NEW BRITAIN - HARTFORD BUSWAY

PERMITTING SUBMISSION

EAST STATION

State Project No. 88-H039

DRAWING TITLE:
**EAST STREET STATION
GRADING PLAN**

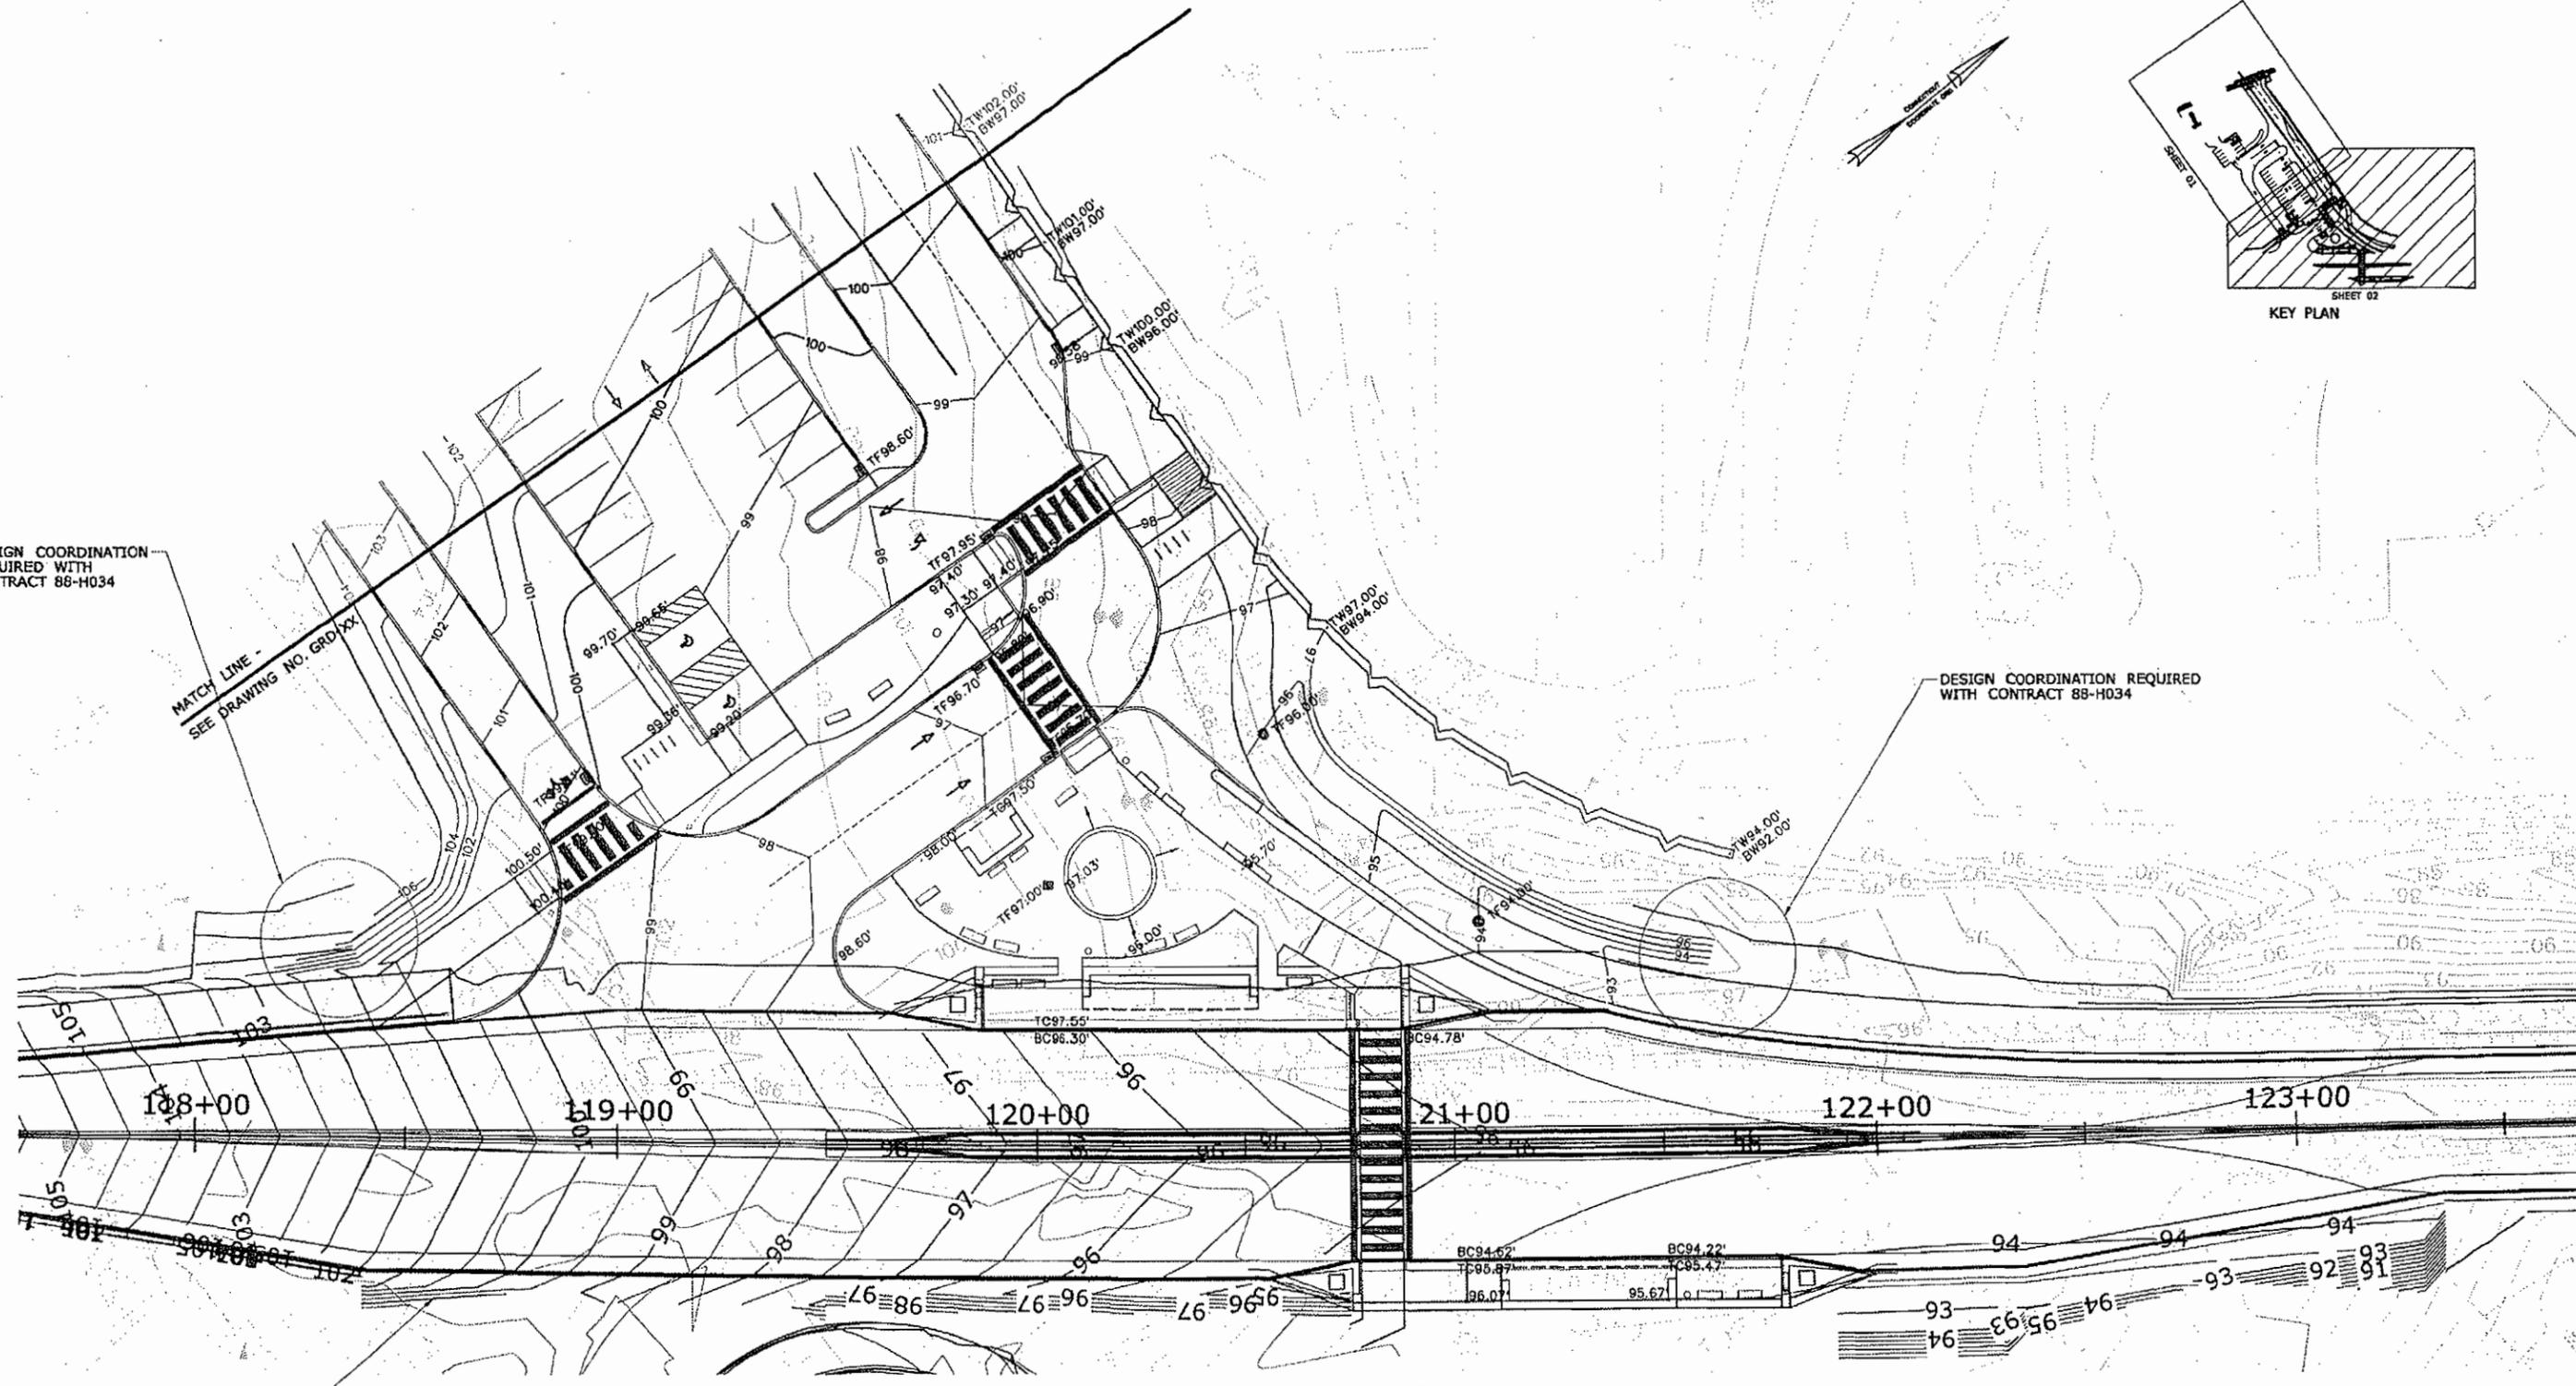
No.	Comment	Inc.	Not Inc.
1	Drawing No. GRD-XX: The grading plans show low points without drainage features at the following locations. Provisions should be made to address the drainage issue. a. Low point at the northeast corner of the small parking lot adjacent to an existing two story building. b. Low point at the parking lot thruway (90 degree bend) near the multi-trail access point.		
2	Drawing No. DRG-XX: a. The plan shows a proposed hydrodynamic separator at the end of the drainage system just prior to leaving the East Street Station limits (near busway mainline Sta. 121+50). The system then connects to the busway mainline drainage system and discharges at Sta. 123+00. If a hydrodynamic separator is deemed necessary, it should be located just prior to the mainline drainage discharge point in order to treat the remainder of the flow. b. A pipe connection is shown from the East Street Station to the busway mainline near Sta. 119+50. The source of this pipe flow is not clear.

1	<p>Drawing No. GRD-XX:</p> <p>The grading plans show low points without drainage features at the following locations. Provisions should be made to address the drainage issue.</p> <p>a. Low point at the northeast corner of the small parking lot adjacent to an existing two story building.</p>
---	-----------------------------------------------------------------------------------------------------------------------------------------------------------------------------------------------------------------------------------------------------------------------------------------------------

b.	Low point at the parking lot thruway (90 degree bend) near the multi-trail access point.
----	------------------------------------------------------------------------------------------

S E A Response: *An existing dry well is in this location and will remain in use following the site development.*

S E A Response: *Additional spot elevations have been added to the grading plan to clarify drainage patterns.*

TOWN:
NEW BRITAIN
DRAWING TITLE:
**EAST STREET STATION
DRAINAGE**

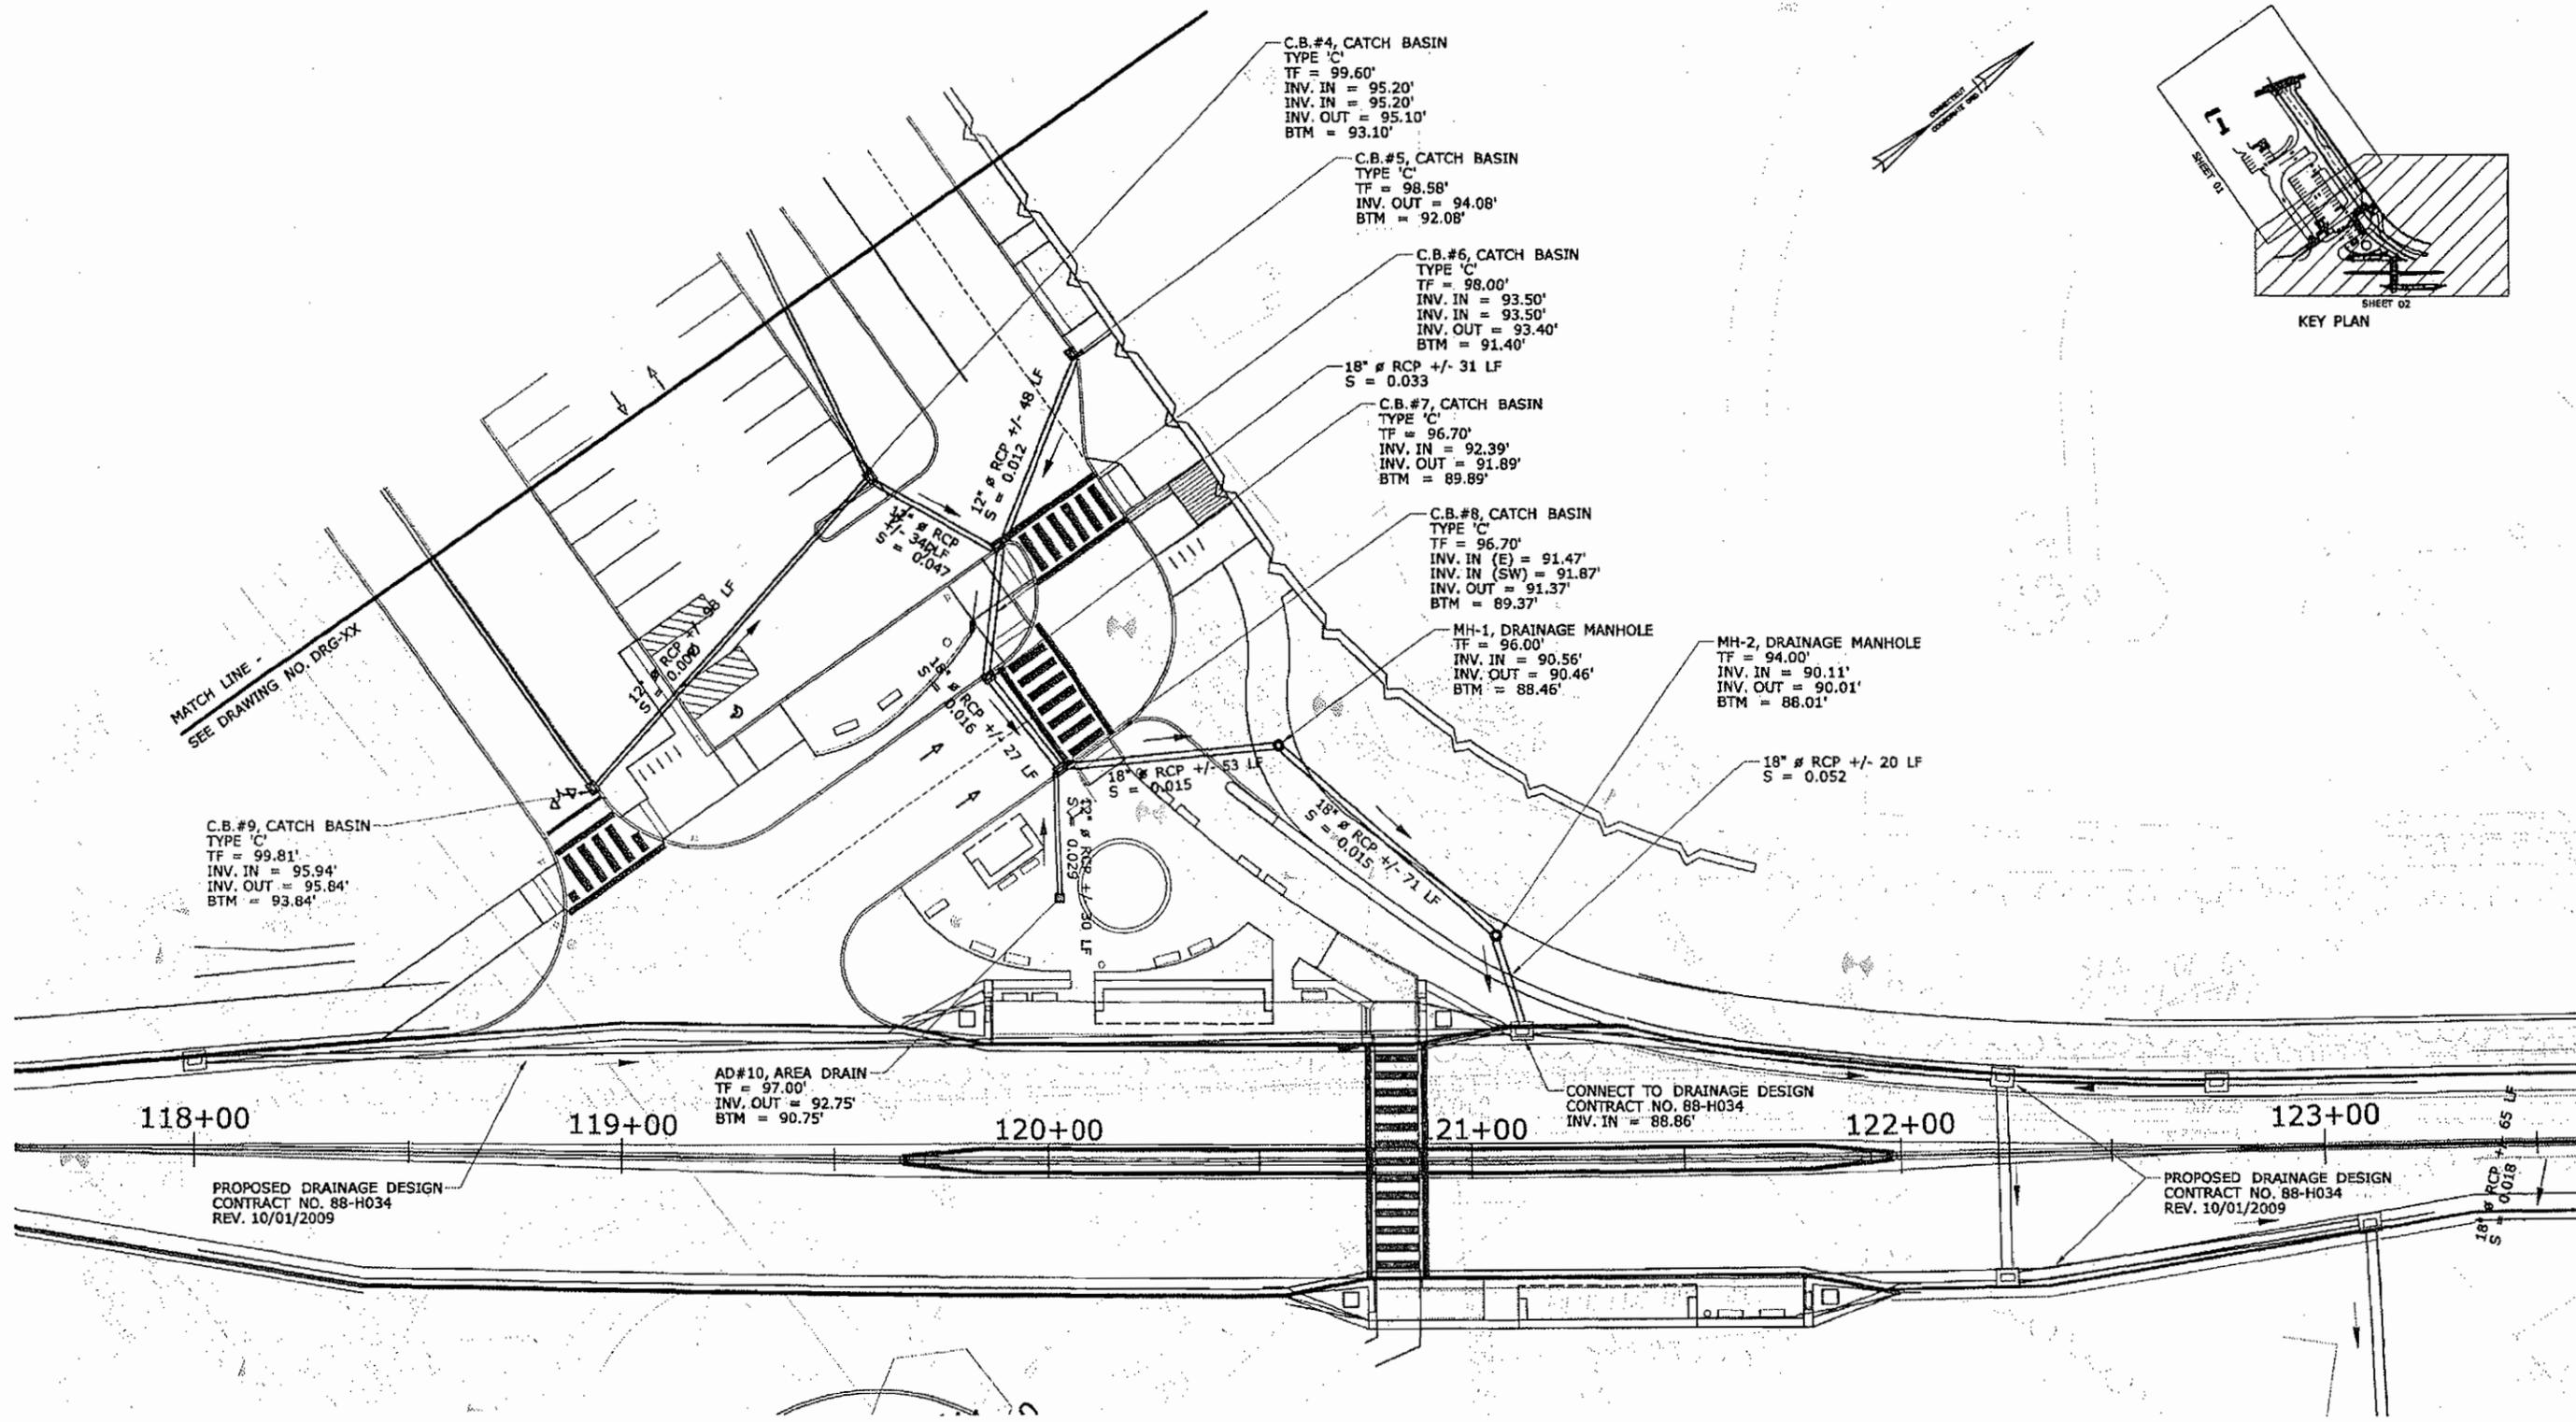
2	<p>Drawing No. DRG-XX:</p> <p>a. The plan shows a proposed hydrodynamic separator at the end of the drainage system just prior to leaving the East Street Station limits (near busway mainline Sta. 121+50). The system then connects to the busway mainline drainage system and discharges at Sta. 123+00. If a hydrodynamic separator is deemed necessary, it should be located just prior to the mainline drainage discharge point in order to treat the remainder of the flow.</p>
---	----------------------------------------------------------------------------------------------------------------------------------------------------------------------------------------------------------------------------------------------------------------------------------------------------------------------------------------------------------------------------------------------------------------------------------------------------------------------------------------

b.	A pipe connection is shown from the East Street Station to the busway mainline near Sta. 119+50. The source of this pipe flow is not clear.
----	---------------------------------------------------------------------------------------------------------------------------------------------

S E A Response: *The HDS has been removed from the project. The station drainage ties to the mainline system and will receive primary treatment by a proposed water quality basin before discharge to the brook.*

S E A Response: *Coordination is required between S E A and the mainline designers. This work is ongoing.*
